HYDRAULIC AVE.

N.L. I-35 W, TO N.L. S.E. 1/4 SEC. 33, TWP. 26 S, R. 1 E

PROJ. NO. C 15-29

HYDRAULIC AVE.
N.L. I-35W TO N.L. S.E. 1/4,
SEC. 33, T. 26 S, R. I E.
48' 0"-8" CONC. PAVEMENT &
8' ASPH. SHOULDERS
CITY OF WICHITA, KANSAS
B. E. SMITH, CITY ENGINEER
DATE: DEC, 1969 PROJ. NO. C 15-29

3/7

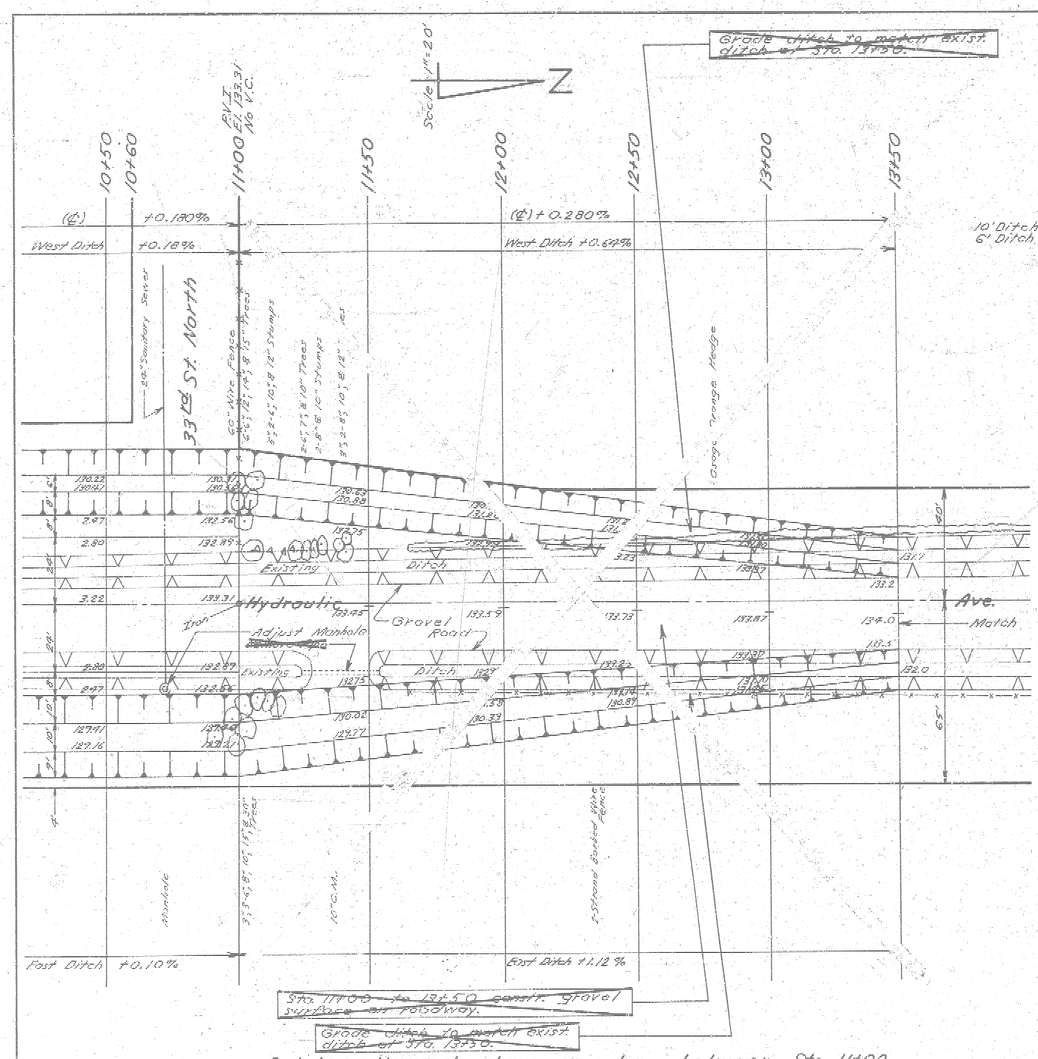
Note: End conc. pavement and asph. shoulders at Sta. 11+00. All construction shown on plans between Sta. 11+00 and 13+50 to be deferred since Sedgwick County is to construct paved road beginning at Sta. 11+00 and extending north of approx. the same time as this project. Lump sum bid item of clearing right-of-way to include all costs for removing all brush, stumps, hedge, trees, and fences.

4/7

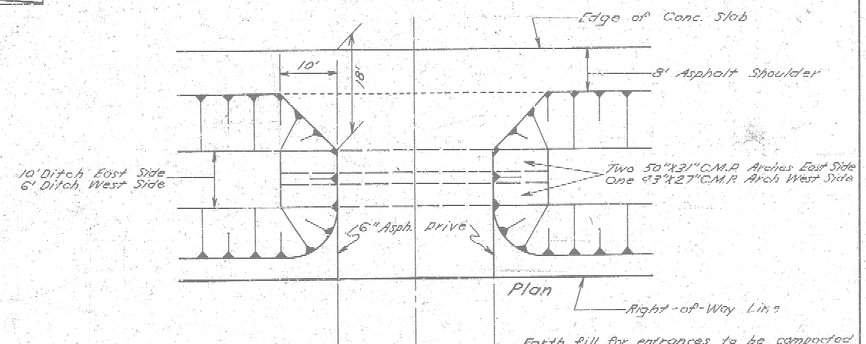
Delete all work shown on plans between Sta. 11+00 and 13+50. See note on sheet 3.

Note: ~~Sta.~~ 6" of roadway between Sta. 11+00 and ~~13+50~~ to be compacted to some density requirements as required by Specifications for subgrade under pavement. Lump sum item of clear right-of-way is to include all costs for removing all brush, stumps, hedge, trees and fences.
